Work Order ID 79629

Item Name: Crosstube Mid Fwd, Blue

DRAWING NO. D206-667-147
TITLE CROSSTUBE ASS'Y (206L MID FWD)
SCALE NTS

DRAWING NO. D206-667-147	TITLE CROSSTUBE ASS'Y (206L MID FWD)	REV. A	DART AEROSPACE LTD ENGINEERING ORDER		D.E.O. NO. D206-667-147-A-1	SHEET NO. SHEET 1 OF 1	SCALE NTS
DRAWN 92	CHECKED ADS	MFG. APPR. [Signature]	APPROVED [Signature]		DE APPR. [Signature]		
DATE 11.07.15	DATE 11.07.20	DATE 11.07.21	DATE 11/07/21		DATE 11.07.21

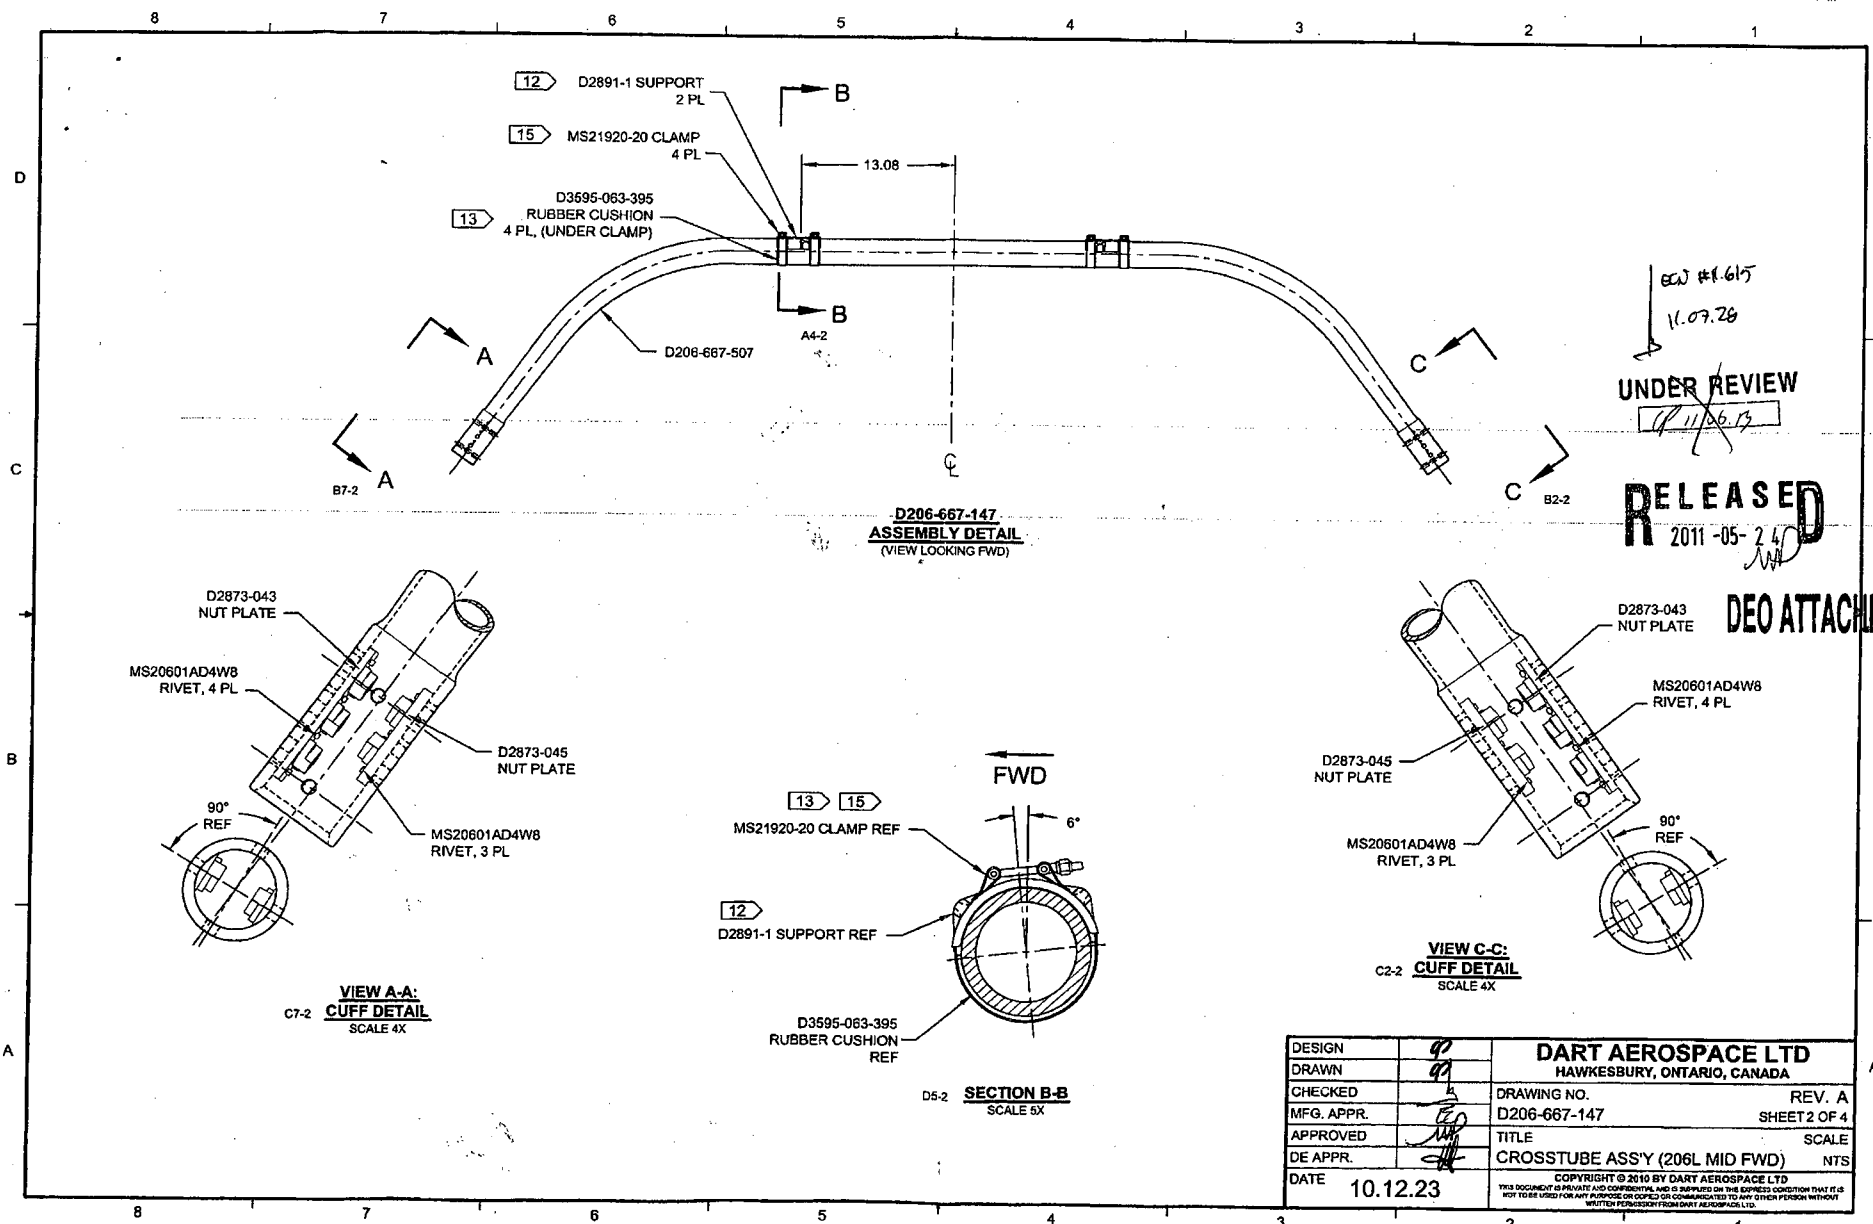
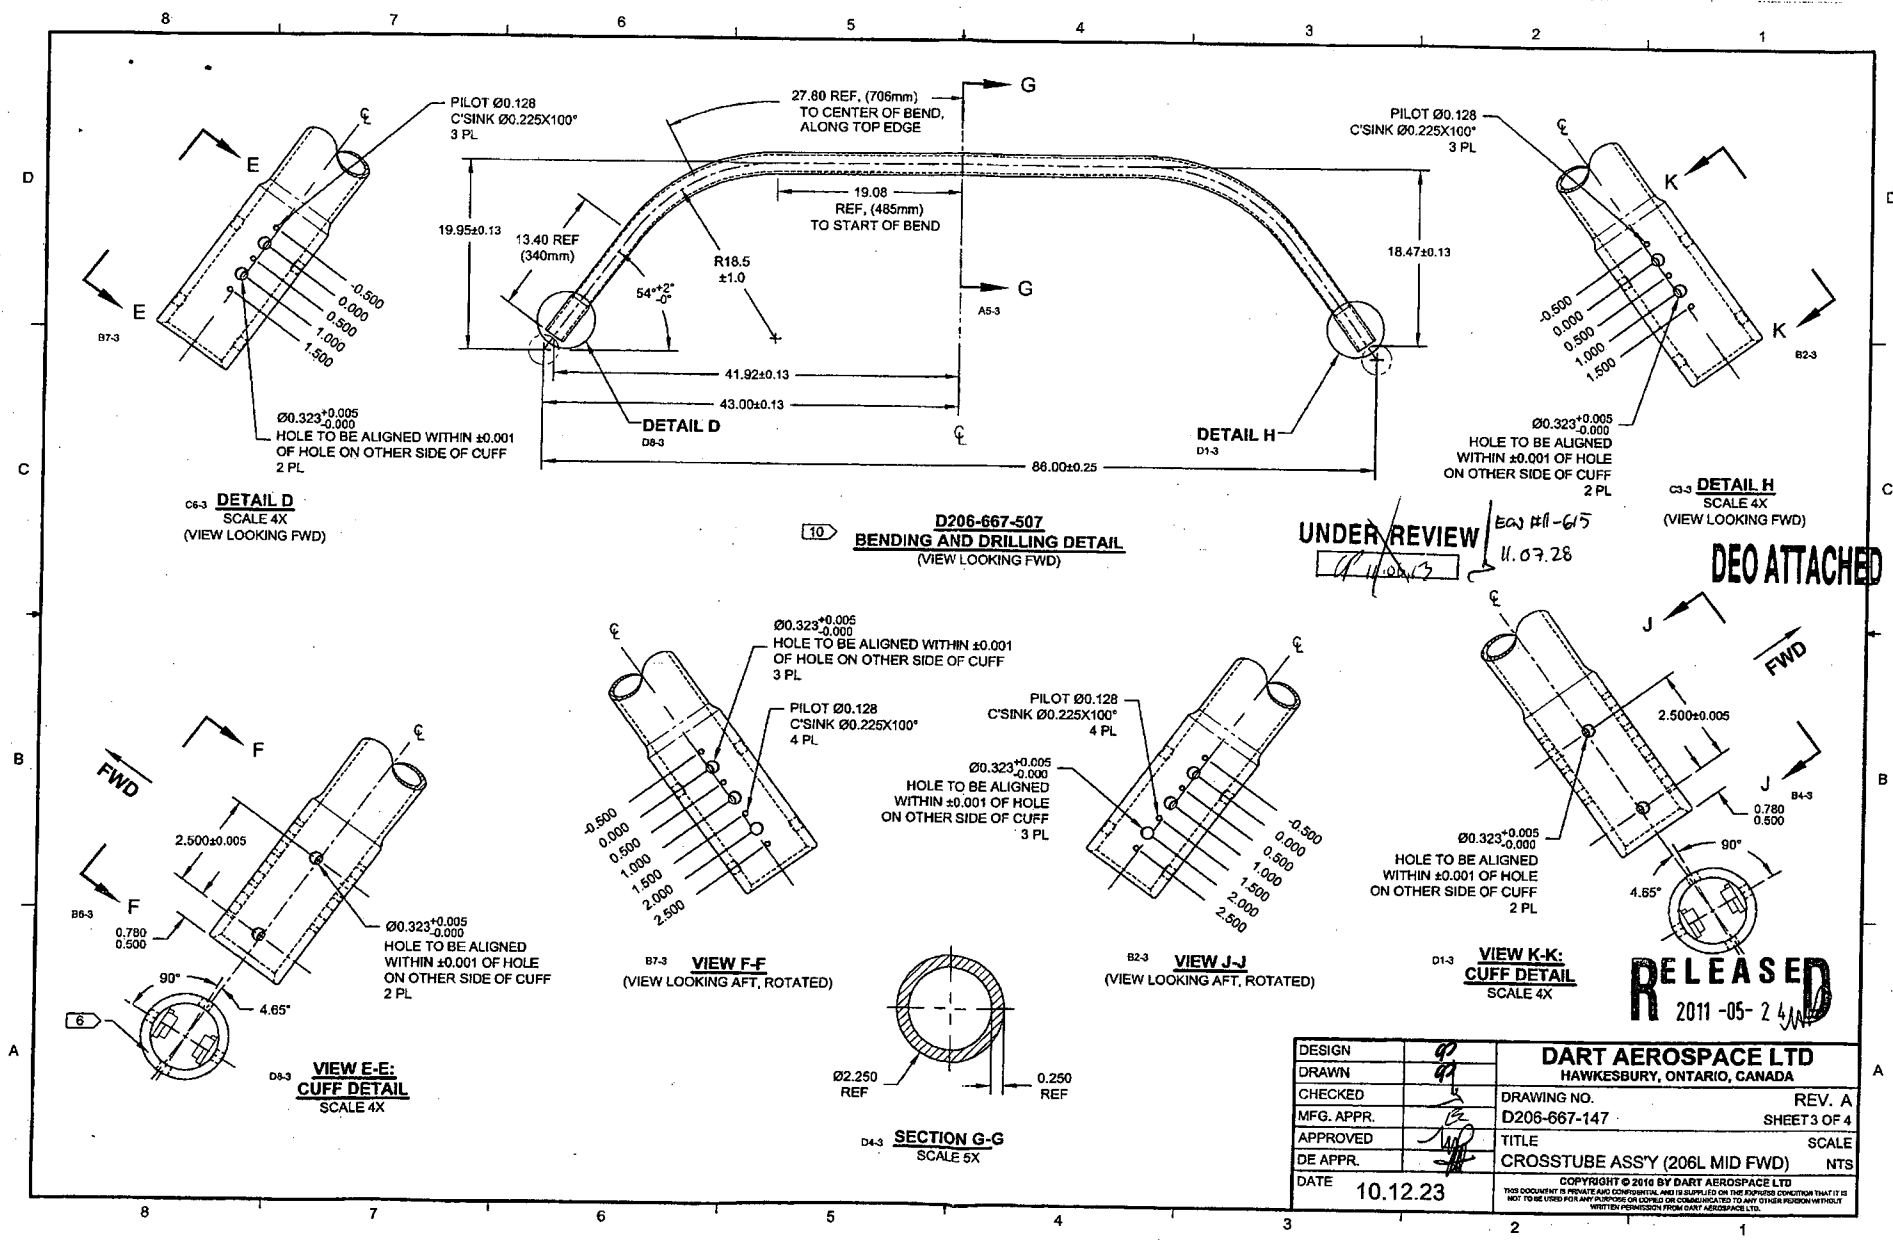
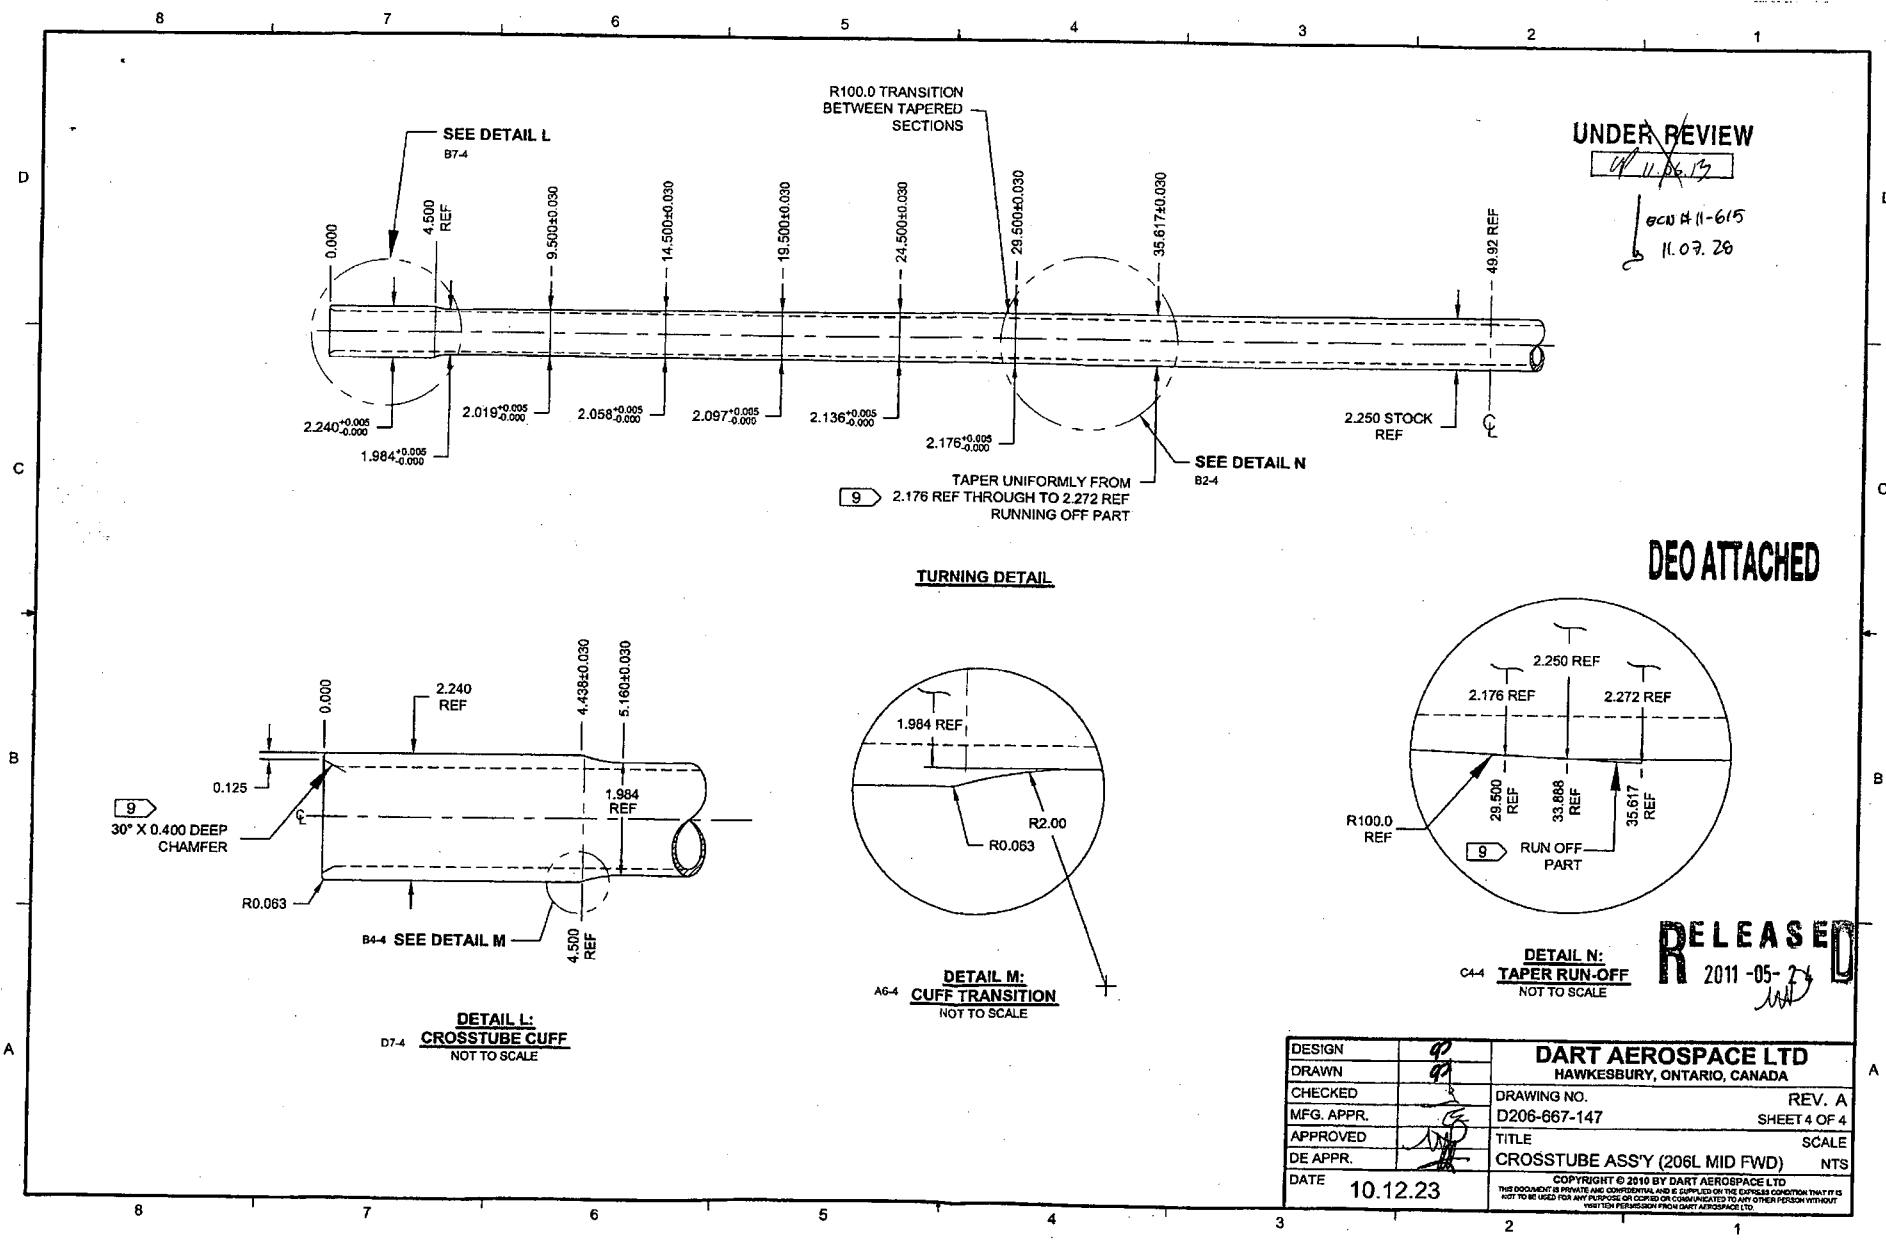
REPLACE MAGNOBOND WITH PROSEAL.

Item	Qty -147	Part Number	Description
9	A/R	PROSEAL 890 B-2	SEALANT, AMS-S-8802 CLASS B-2

9	A/R	MAGNOBOND 6398	ROCKWELL SPECIFICATION RBO-120-023 ADHESIVE (TEXTRON/BELL SPEC. 299-947-100, TYPE II, CLASS 2 ADHESIVE)
---	-----	----------------	---

NOTE 12 & 15, SHEET 1 IS AMENDED AS FOLLOWS:

- 12) INSTALL D2891-1 SUPPORT USING 0.03" TO 0.06" THICK LAYER OF MAGNOBOND 6398 PER QSI 015. LET CURE FOR 12 HOURS AFTER INSTALLATION AND PRIOR TO PACKAGING.
- 15) TORQUE CLAMPS 80 TO 100 IN-LB. ENSURE AT LEAST 1.5 THREADS SHOWING IN SAFETY AND THAT NUT HAS NOT BOTTOMED-OUT AFTER TORQUING.

- 12) TO INSTALL D2891-1 SUPPORT: ABRASE MATING SURFACE OF SUPPORT AND CROSSTUBE WITH 180-GRIT SANDPAPER AND REMOVE RESIDUE WITH MEK (OR EQUIVALENT). APPLY A 0.04" TO 0.07" THICK LAYER OF PROSEAL 890 CLASS B-2 (OR AMS-S-8802 CLASS B-2) SEALANT TO MATING SURFACE OF SUPPORT.
- 15) TORQUE CLAMPS 80 TO 100 IN-LB. ENSURE AT LEAST 1.5 THREADS SHOWING IN SAFETY AND THAT NUT HAS NOT BOTTOMED-OUT AFTER TORQUING. **PRIOR TO PACKAGING, RE-CHECK TORQUE ON CLAMPS AFTER PROSEAL 890 SEALANT HAS CURED FOR 72 HOURS.**
